Meeting Agenda

Franklin Municipal Planning Commission

Thursday, January 24, 2019

40. Riparian Buffer

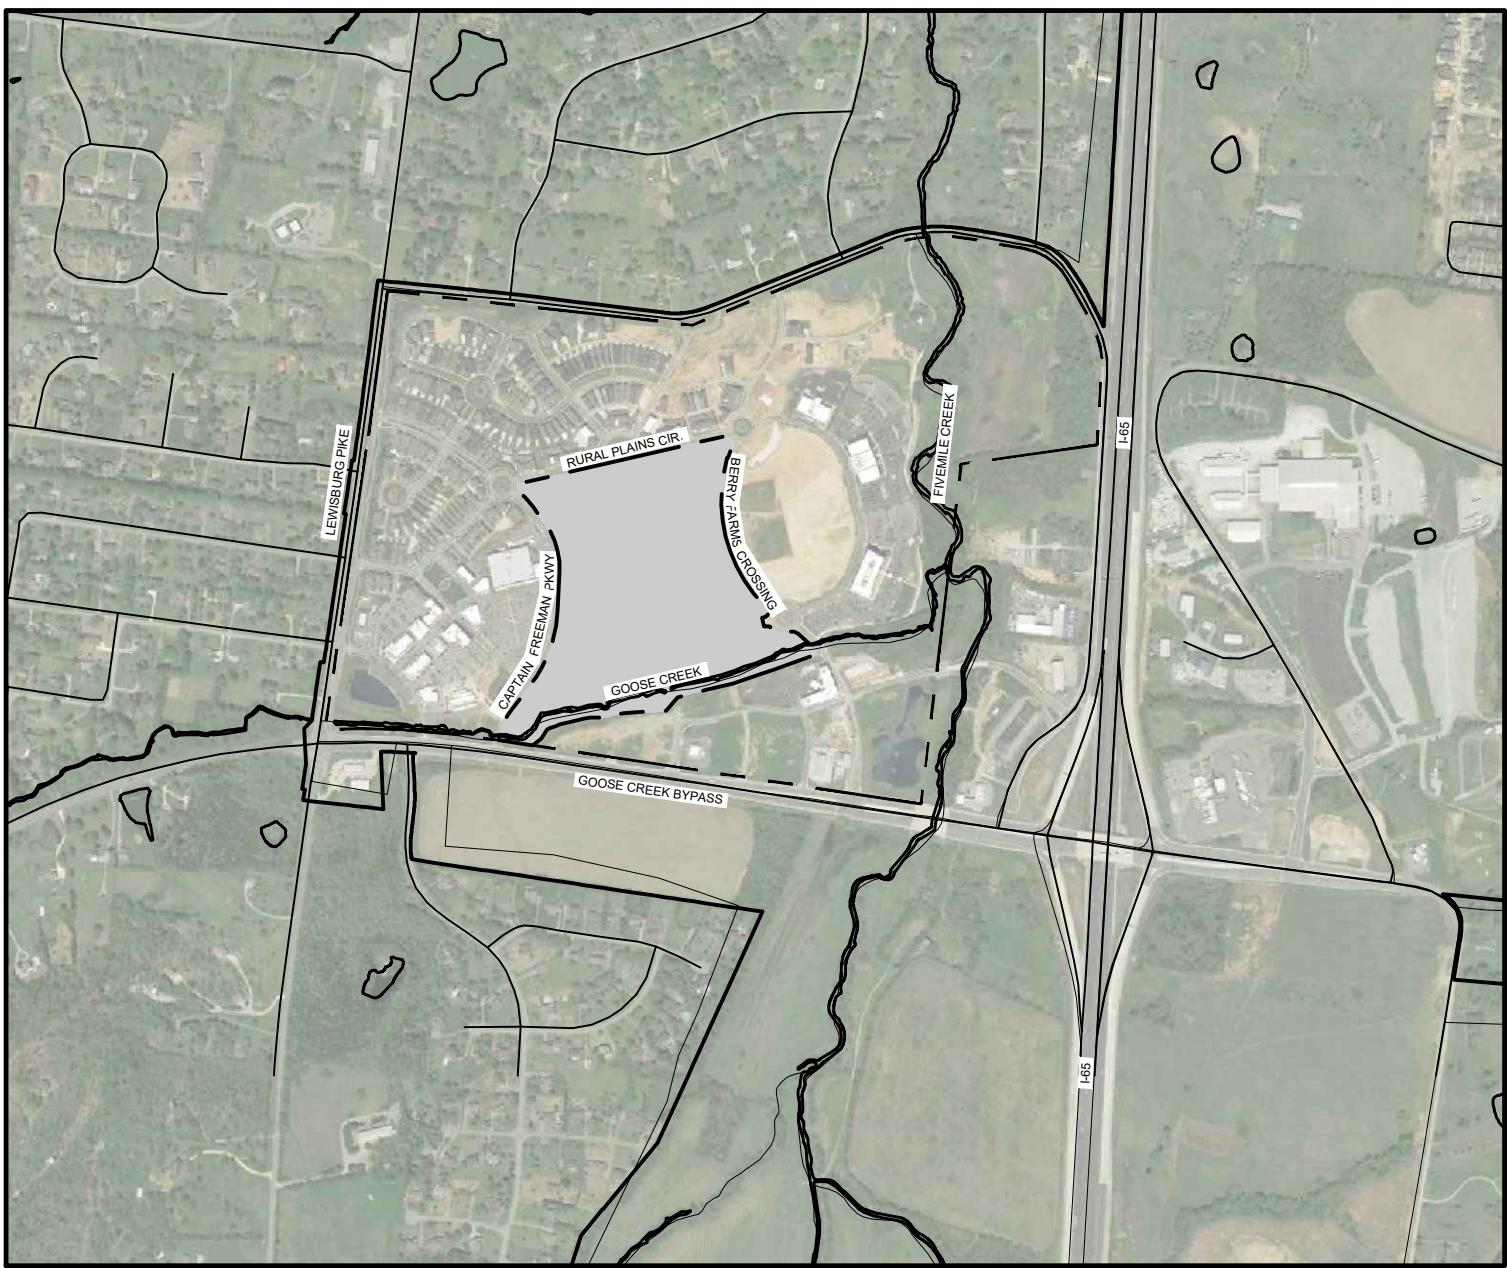
jeff.willoughby@franklintn.gov This shall be applied on sheet C2.0 as well

jeff.willoughby@franklintn.gov This shall be applied on sheet C2.0 as well

35. Easements

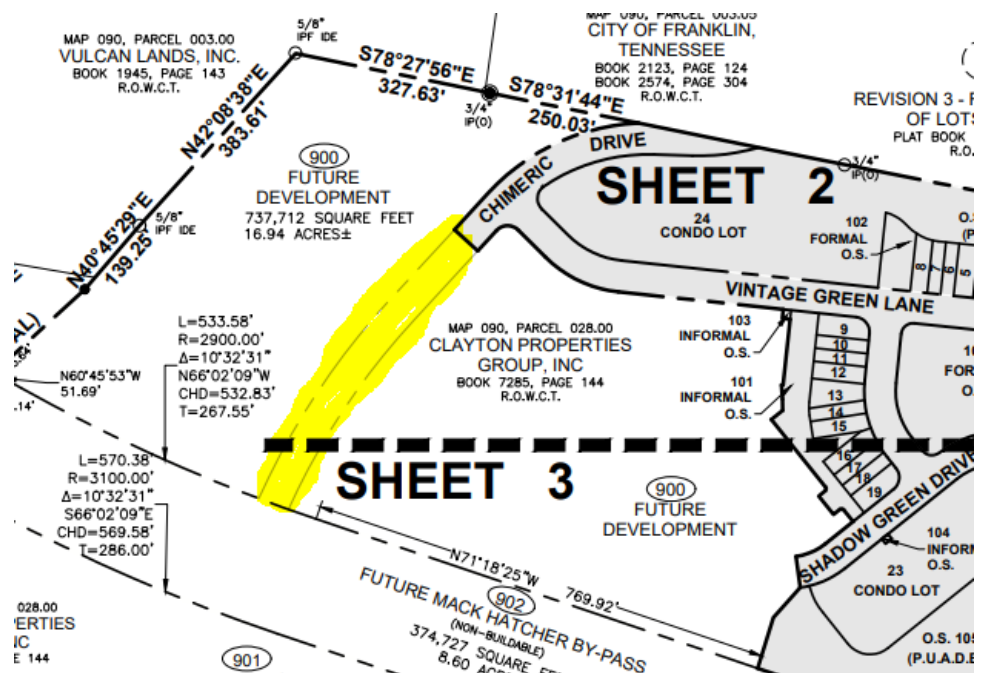
christopher.andrews@franklinton.gov Please label the portion of future ROW of Chimeric Drive that is not included as part of Section 1 as an easement on the submitted plat.

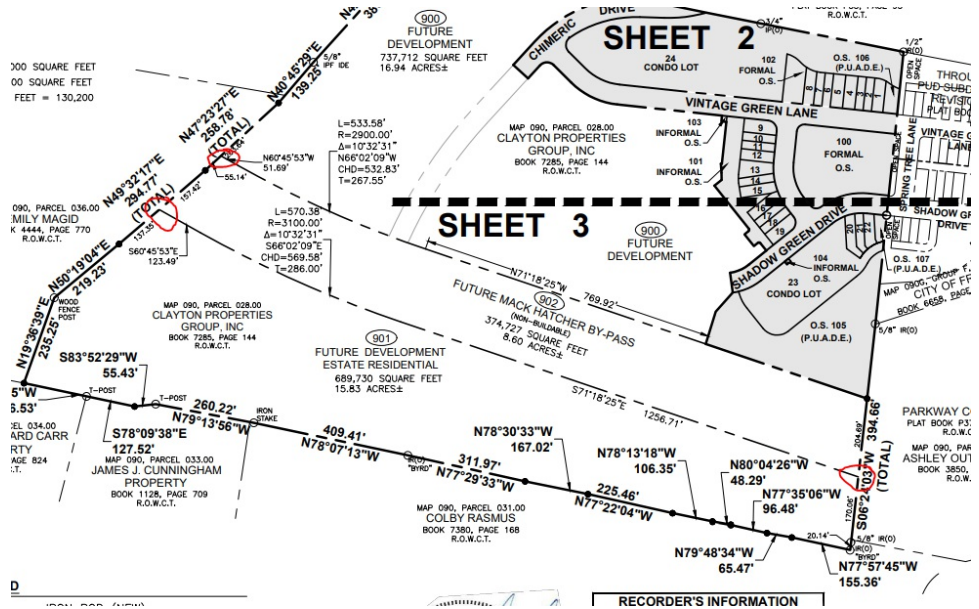
(Currently, Tract 1 and Tract 2 are not listed as lots. Nor is the Mack Hatcher ROW.)

Please revise the plat to include those lots, and assign lot numbers. (You may choose to use a "#00-series" system, example: Lot 900=Tract 1, Lot 901=Tract 2, Lot 902=Mack Hatcher ROW).

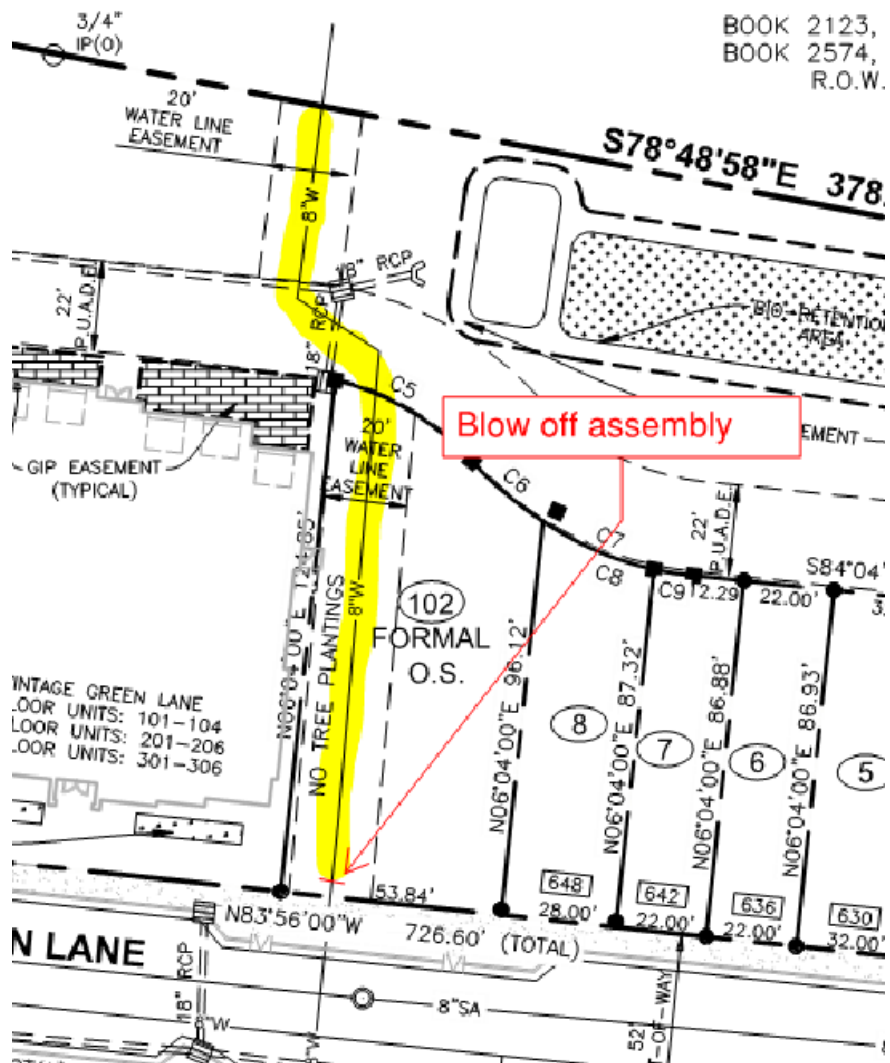
jeff.willoughby@franklntn.gov The note shall state "or" HOA

Provide note "Maintenance of all stormwater management features shall be the responsibility of the property owner(s) or HOA".

23. Stream

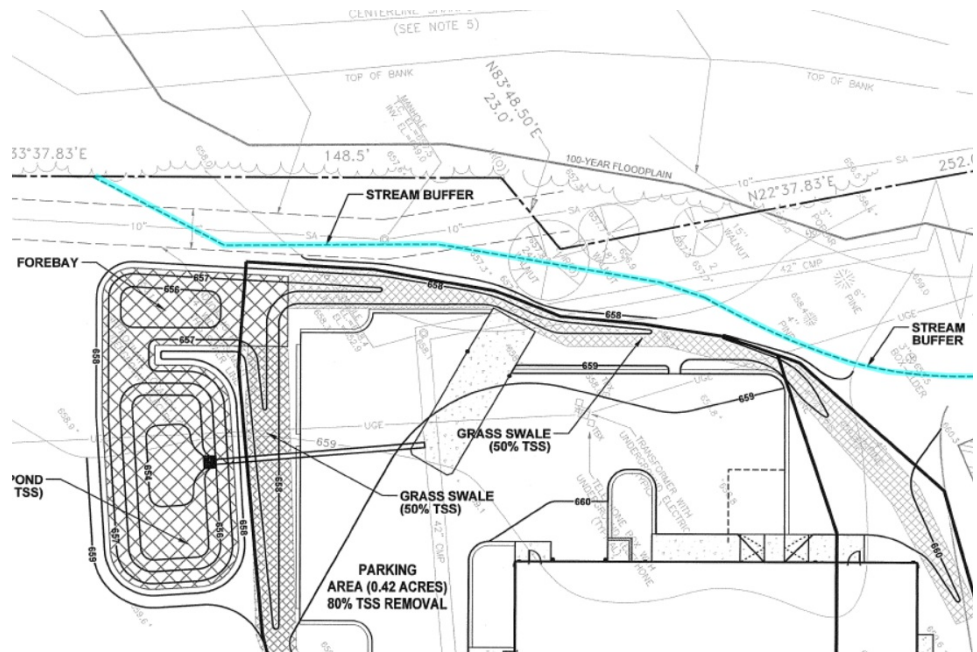
jeff.willoughby@franklintn.gov Identify and label West Main Branch

West Main Branch (Sharps Branch) added to sheets 1, 2 and 3.

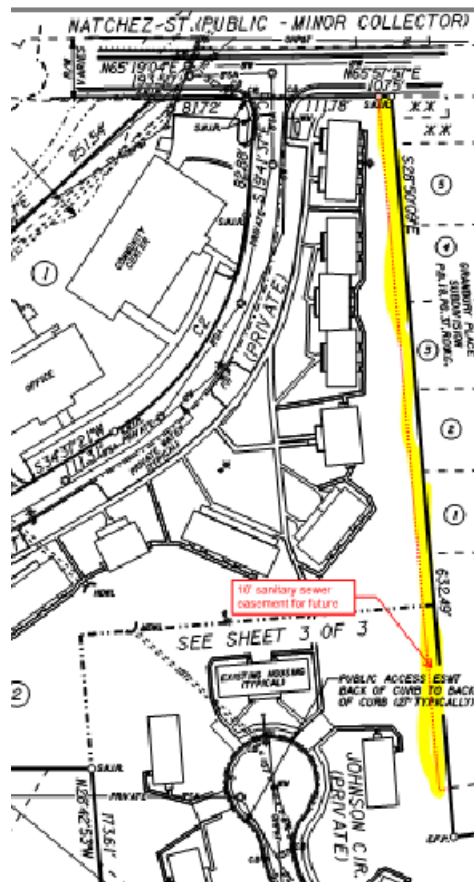
In addition to Lance's comment provide note:

There shall be no mowing, clearing, grading, construction, storage, or disturbance of vegetation of any kind in riparian buffers except as approved by the City Engineer
[Edited By Jeff Willoughby]

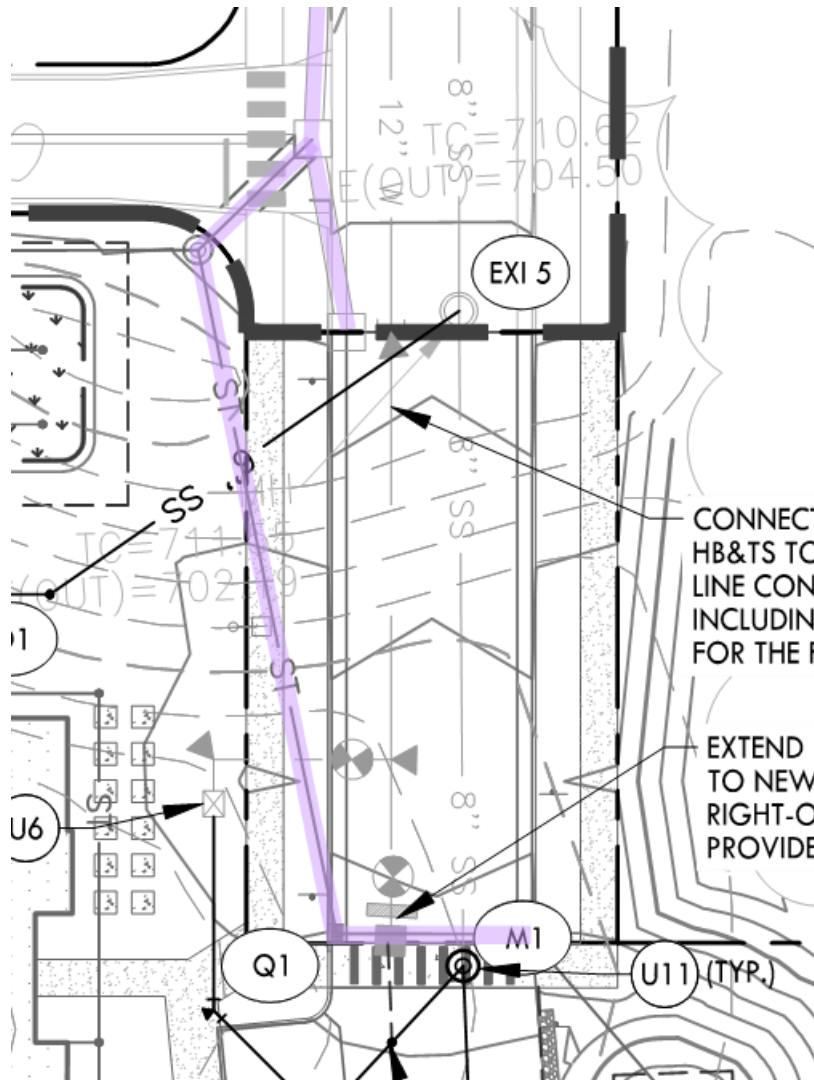
The portion of the storm sewer infrastructure highlighted below which conveys runoff from public ROW will be a public line. This line requires a 20' drainage easement

centered on the line (10' on each side of the line) where it crosses out of the existing/proposed ROW. Applicant shall show the line and its associated easement on the plat. The portion of easement which would fall within the existing or dedicated ROW need not be shown.

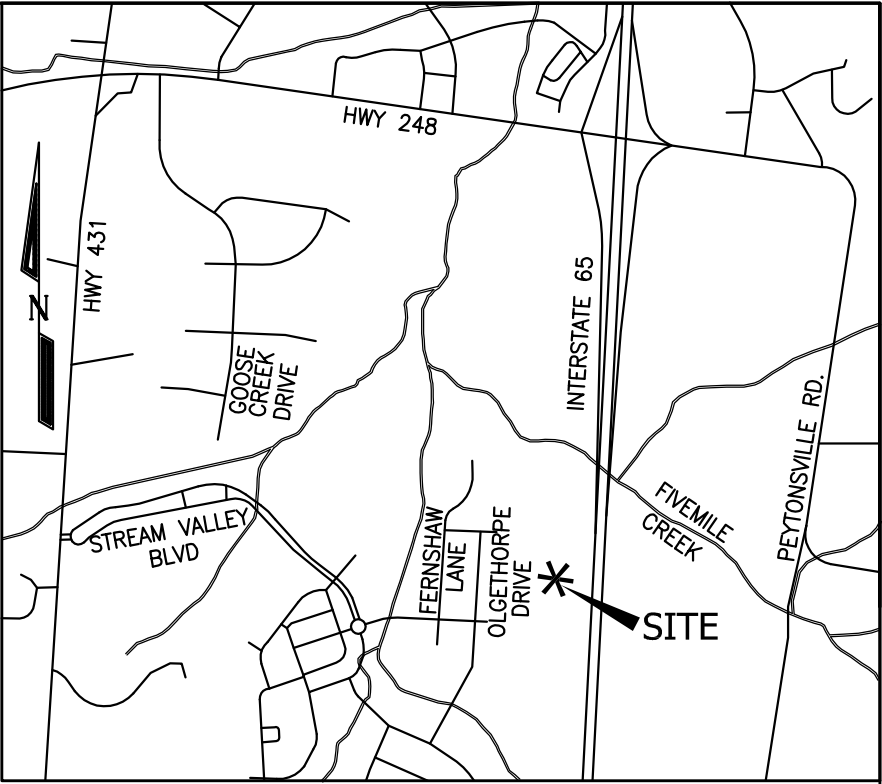
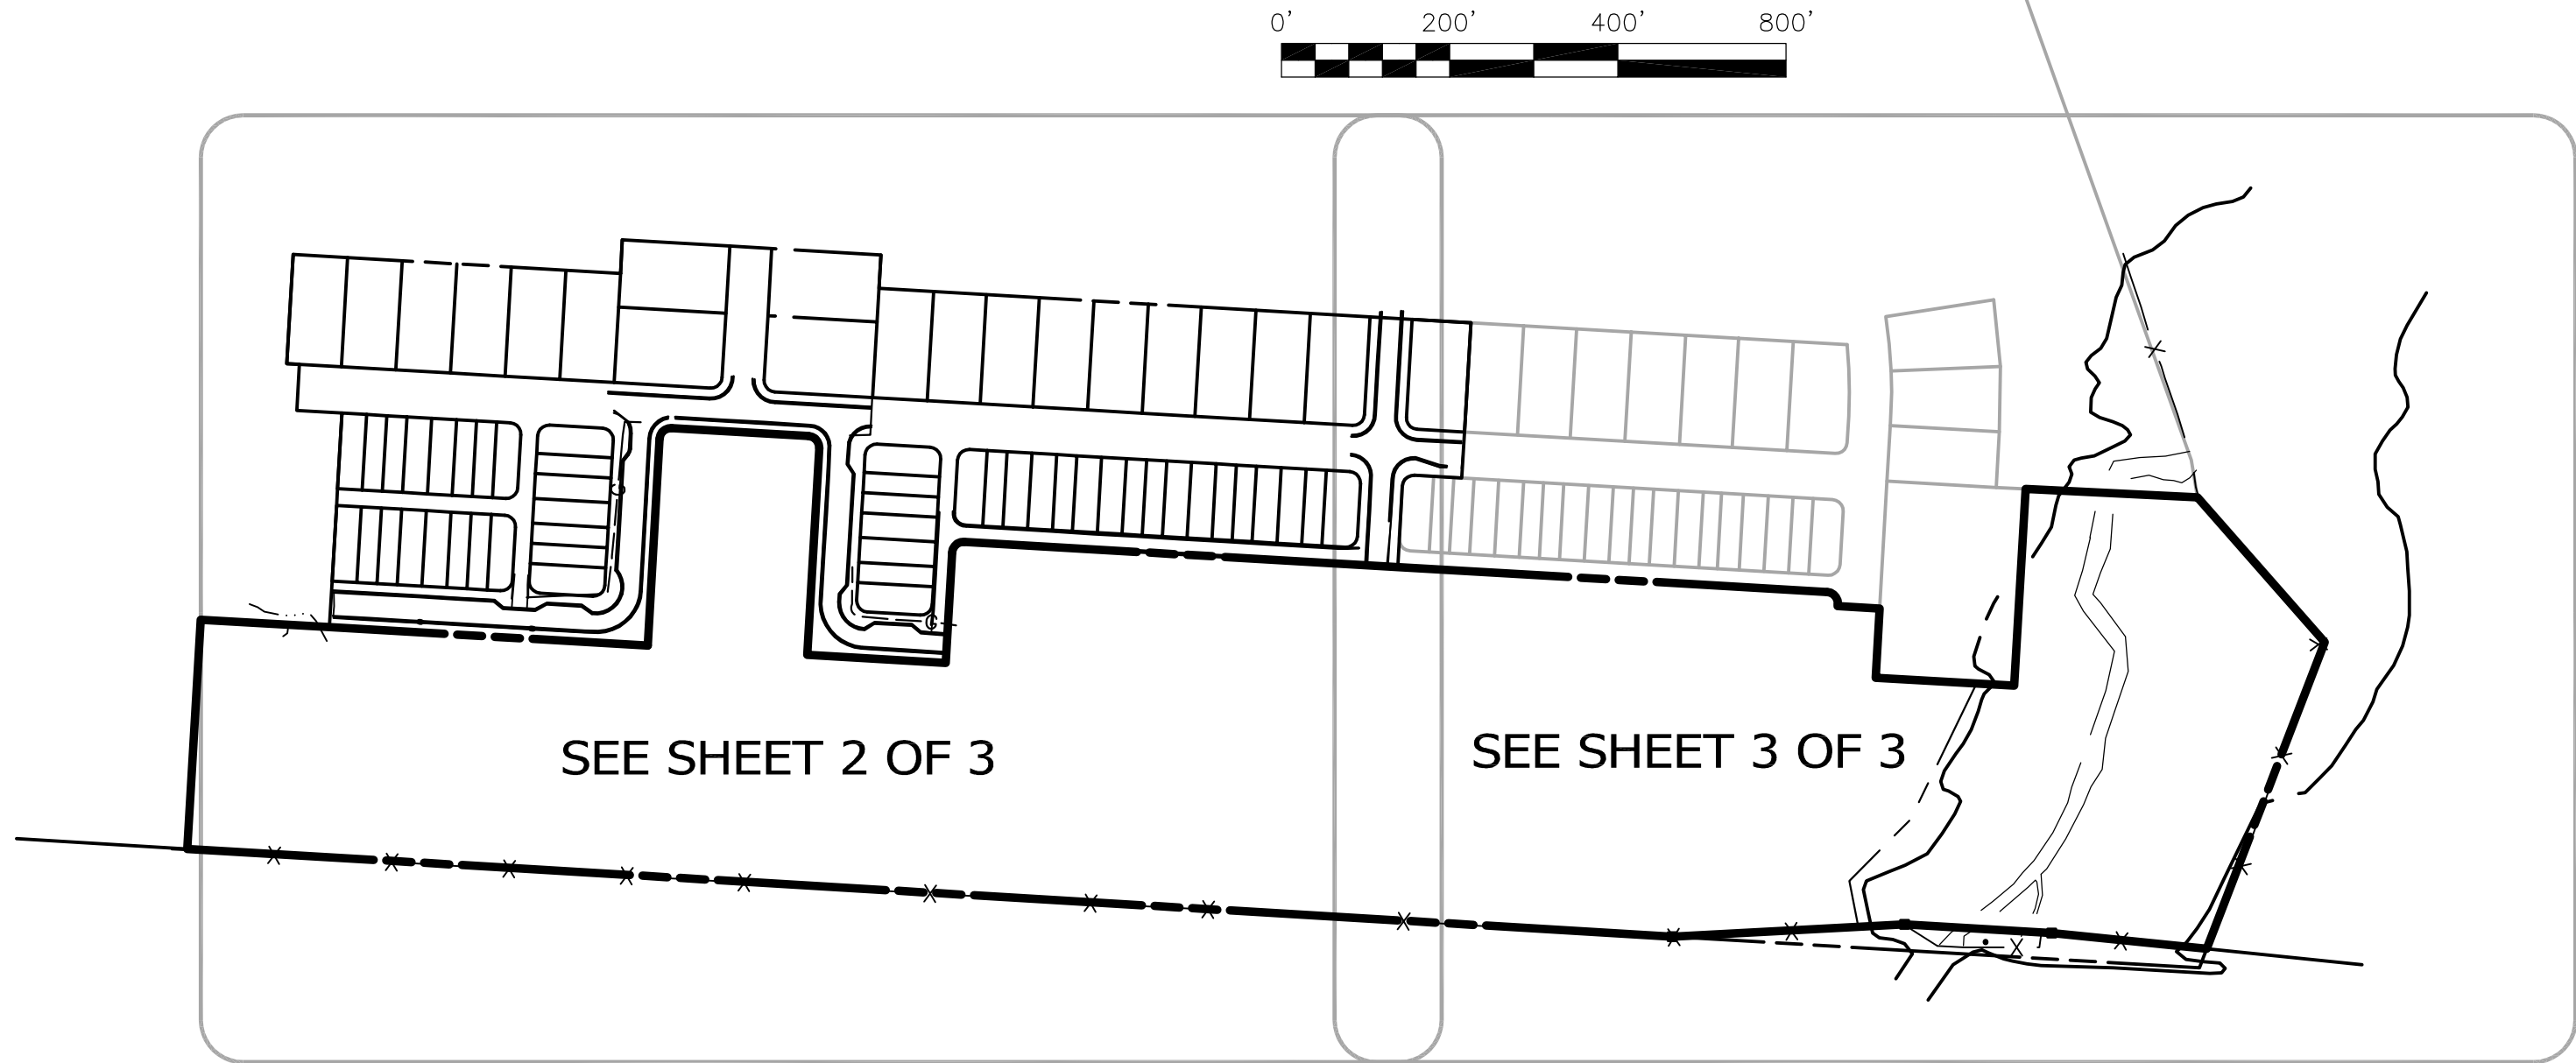
(Sidewalk and stormwater sureties are for the area in and adjacent to public right-of-way, as highlighted below.)
